Addendum 01

PRE-BID MEETING AGENDA/MINUTES

Project: H-92412 First Street, Hamilton to Apple

Date: Wednesday, September 18, 2024

First Street, pump bypass detail info

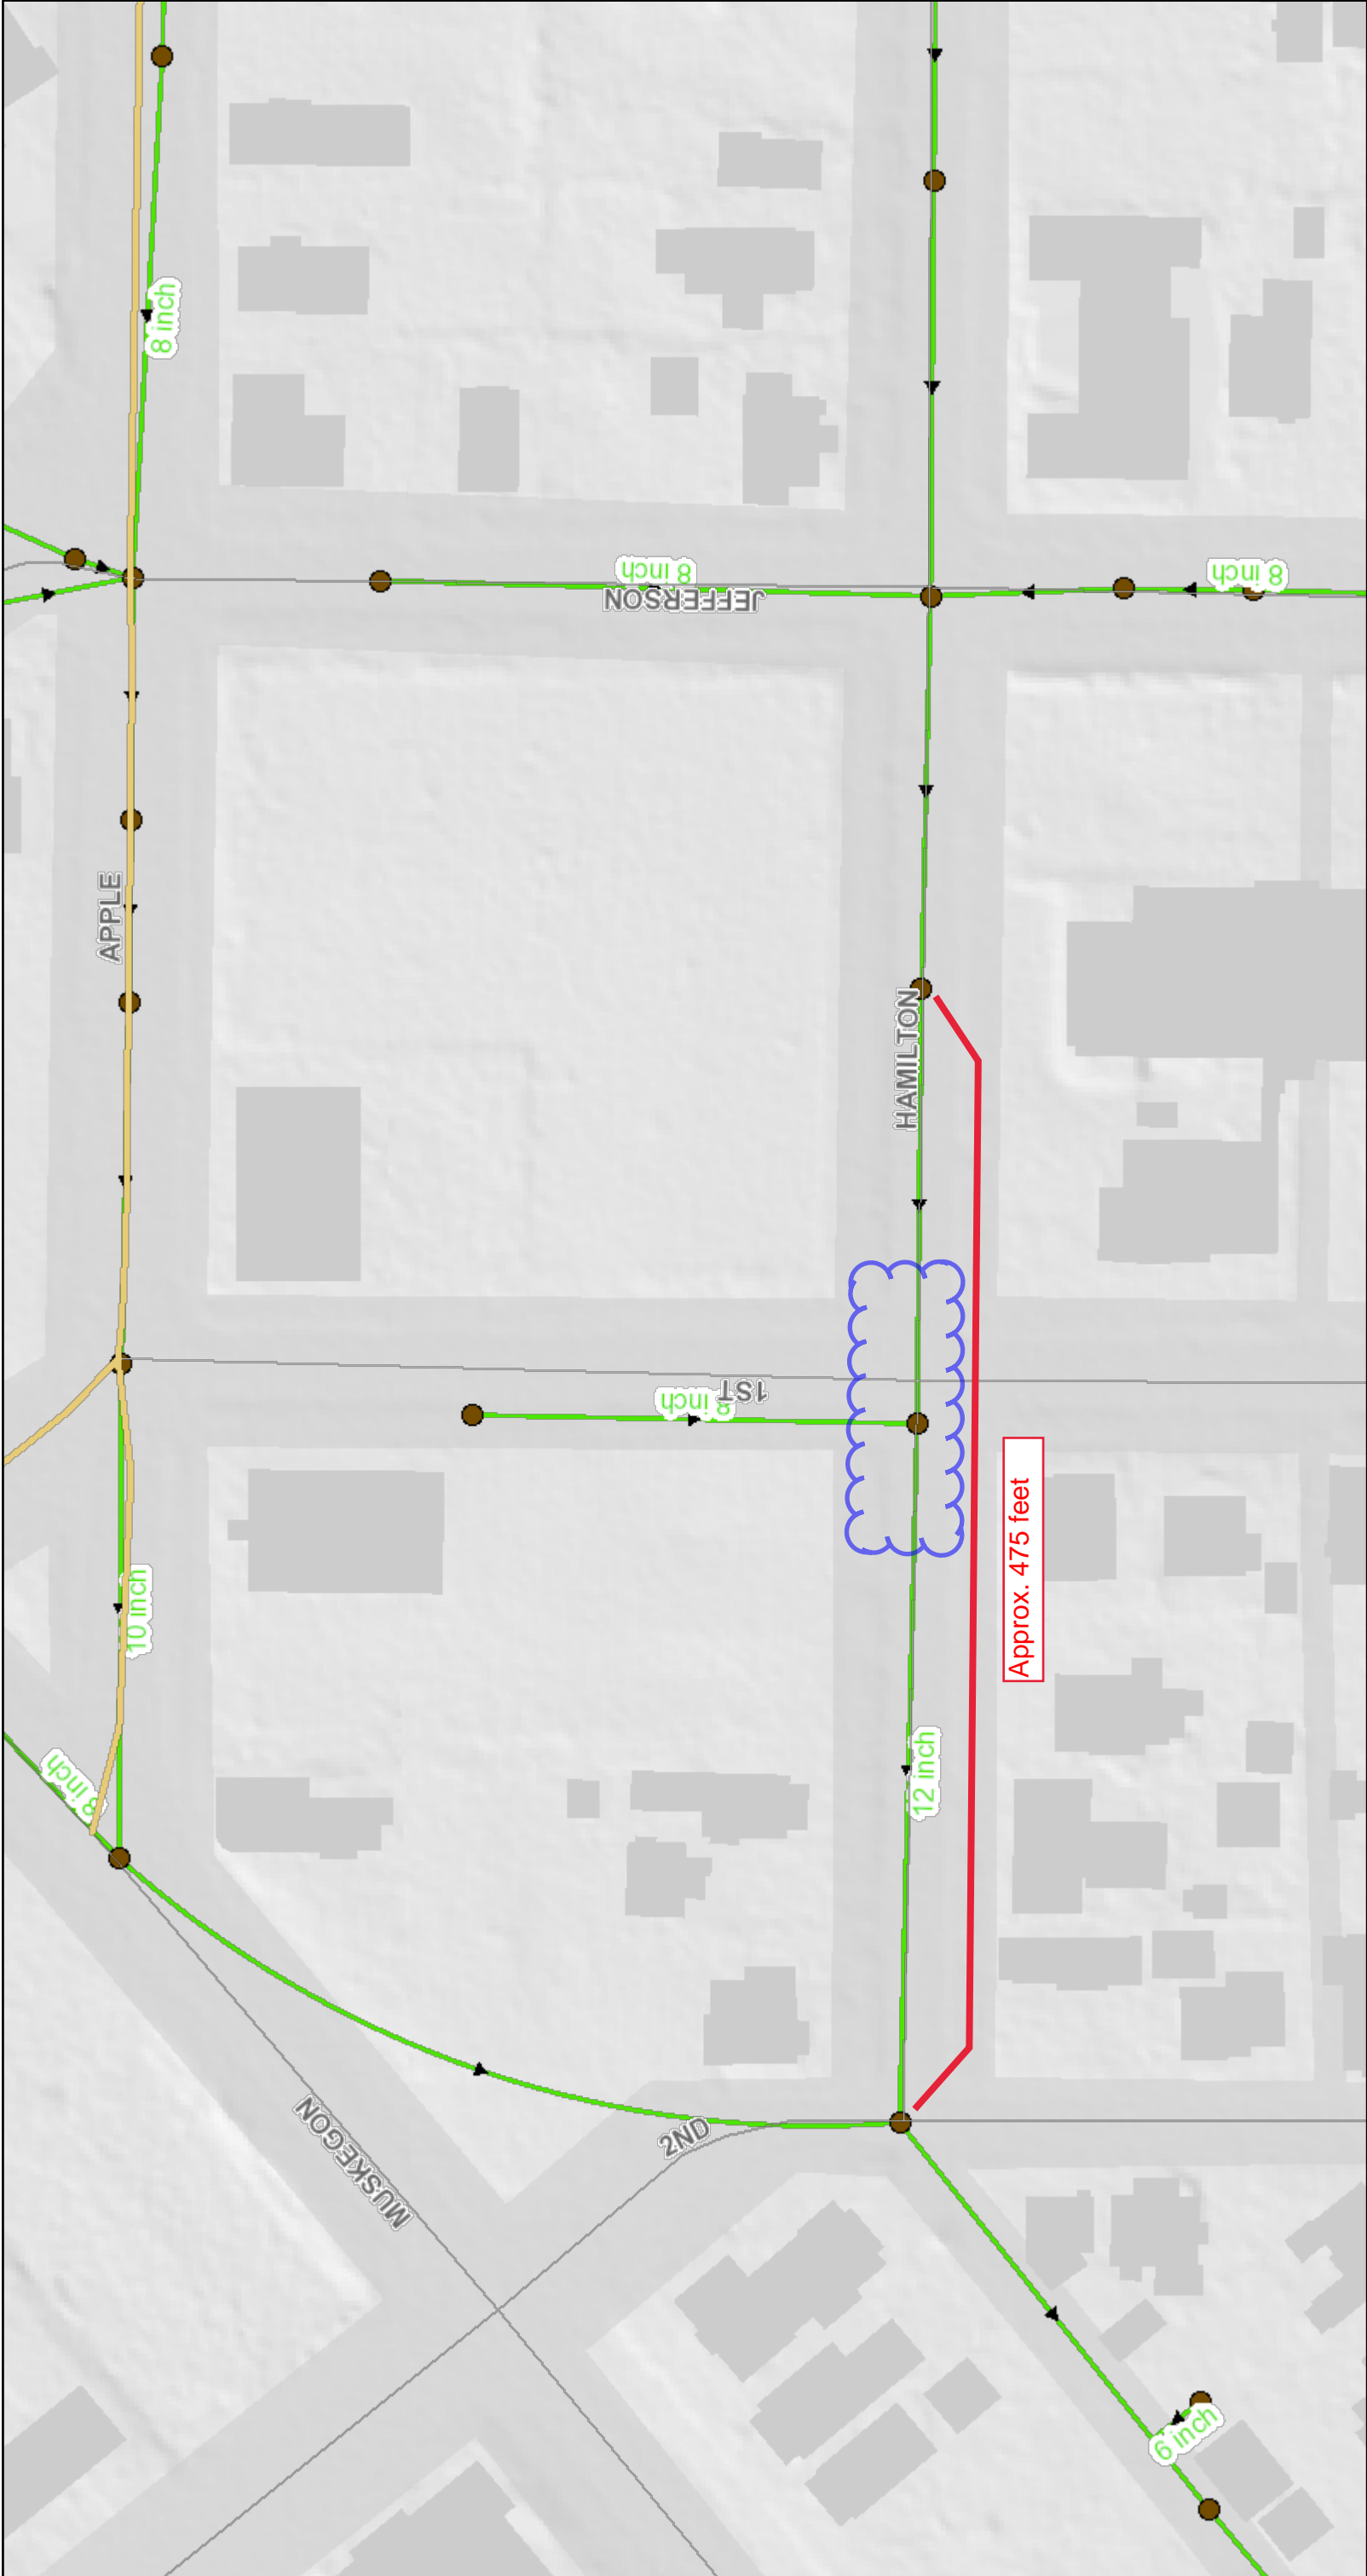
3. Pump bypass: Can more details be shared, distance and expected flow rates?
 - a. Distance of pumping is approx. 475 feet. See attached map.
 - b. Flow rates have not been measured. The 12 inch normally flows about 10% to 25% full. Expect 500 gpm.
4. Special Provisions for MACHINE GRADING, MOD and PAVT, REM, MOD; were inadvertently not modified for this project. The notes within the plan set are correct. Please delete these two SP's from the spec and add the following SP's.
